**PARTS & SERVICE
NEWS**

REF NO.	AT01246
DATE	Jan. 31, 2002

SUBJECT: REPAIR OF TURBOCHARGER ON SA(A)6D140 ENGINE**PURPOSE:** To introduce improved parts to shorten the oil feed delay time to the turbocharger of the SA(A)6D140 series engines**APPLICATION:** SA(A)6D140 Engines, Serial Nos. is refer to pages 4 and 5.**FAILURE CODE:** A900FR**DESCRIPTION:**

Fig. 2 Improved thermo-valve

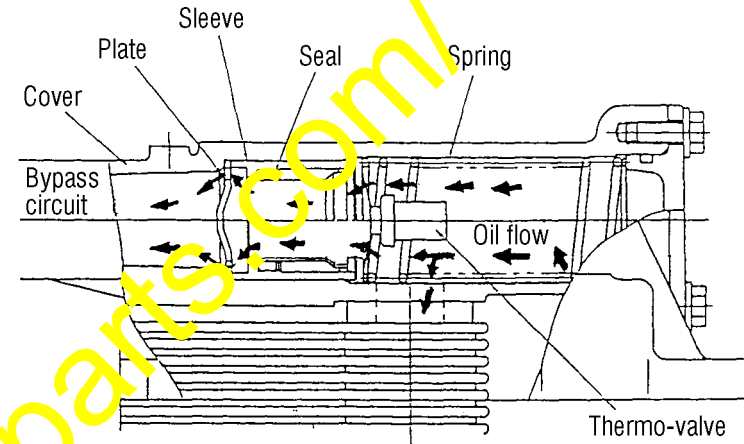
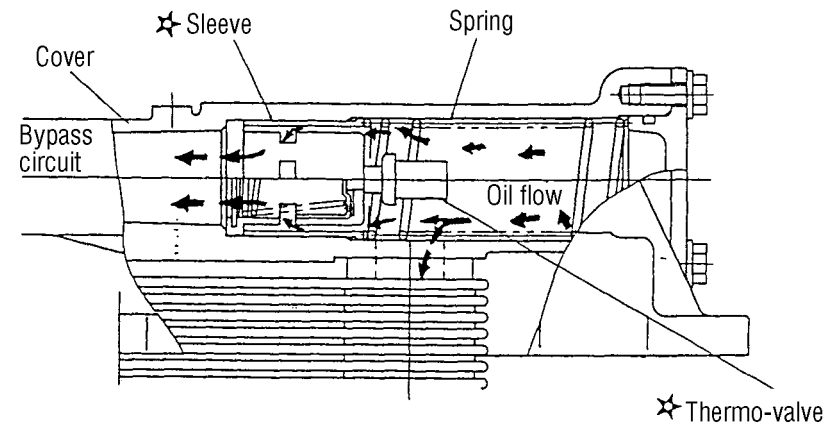
- 1) The oil cooler thermo-valve for the SA(A)6D140 series engines is positioned on the upstream side of the oil cooler as shown in Fig. 1.
- 2) Normally, the oil will flow through both of the element and the bypass circuit under low atmospheric temperature to reduce the passage resistance.

- 3) While under high atmospheric temperature, the thermo-valve operates to close the bypass circuit to let the oil flow through the element totally, thus making it possible to cool the oil efficiently.

- 4) If oil of a higher viscosity is used under low atmospheric temperature (like when #30 oil is used under -10°C), the high viscosity of the oil may let the thermo-valve operate to close the bypass circuit.

- 5) If the bypass circuit is closed under low atmospheric temperature, the passage resistance increases.
- 6) The above increase of the passage resistance will cause delay in the building up time of the feeding oil pressure to the turbocharger.

- 7) If an operation to raise the engine revolution is made before the feeding oil pressure to the turbocharger builds up, the turbocharger bearing may be seized.

- 8) To solve the above problem, the thermo-valve has been improved as shown in Fig. 2 so that the bypass circuit will not be closed, even when oil of a higher viscosity is used under low atmospheric temperature, by the high viscosity of the oil.

- 9) By this improvement of the thermo-valve, the oil feed delay time to the turbocharger has been shortened.
- 10) Thus occurrence of the seizure accident of the turbocharger bearing has been prevented.

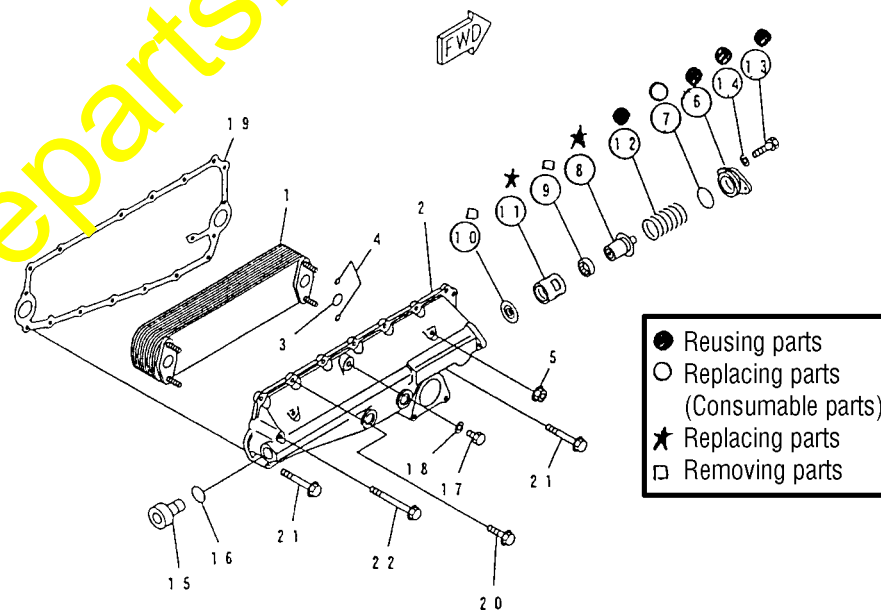
- 1) Loosen the two mounting bolts (13) for the cover (6) of the oil cooler to remove the cover.
- 2) Remove the spring (12), thermo-valve (8), seal (9), collar (11) and plate (10) from the oil cooler.

At this time, remember that removal of the plate (10) is apt to be forgotten.

- 1) Insert the newly prepared improved thermo-valve (8), improved collar (11) and the current spring (12) which was removed while disassembly was being made, in the given order.

The seal (9) and plate (10) will become unnecessary.

- 2) While inserting the thermo-valve, it may stop at the stepped section. Be sure to insert it to the end of the depth securely.
- 3) Confirm if the thermo-valve has been inserted to the end of the depth securely by the fact that the spring is projecting from the end face of the oil cooler by 25 mm after it is installed and when it is in free state.
- 4) If the spring is projecting from the end face of the oil cooler by more than 25 mm, it means that the thermo-valve has not been inserted to the end of the depth. Repeat insertion of the thermo-valve once again to install it properly.
- 5) Change the O-ring (7) to a new part and tighten the cover (6).
Tightening torque: 27 - 34 Nm (2.8 - 3.5 kgm)
